PRODUCT CHANGE NOTIFICATION

Bourns® Model SRN5040 Series Semi-shielded Power Inductors *Additional Source of Supply for Inductor Core & Design and Source of Supply Changes for Cover Tape and Reel*

IC23075

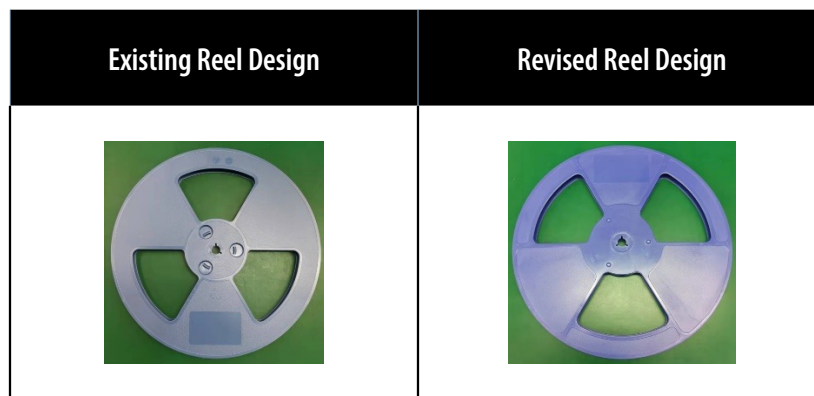
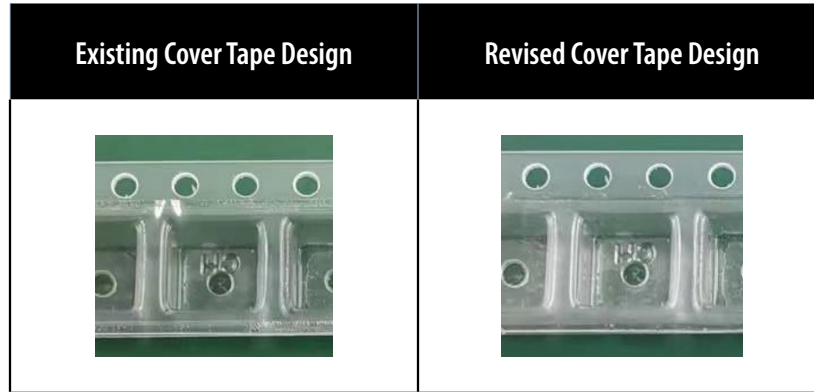
Bourns will also change the design and suppliers of the cover tape and reel for the Model SRN5040 Series Semi-shielded Power Inductors. The cover tape design will be changed from adhesive type to UCT type to improve the sealing quality. The reel design will be changed from assembly type to integral type for a more solid structure.

The form, fit, function, quality, and reliability of the inductors will not be affected by the use of the core from the additional supplier. Only the form and fit of the cover tape and reel, which are packaging parts for the inductors, will be slightly changed due to the design changes. Traceability will be maintained through lot code and date code.
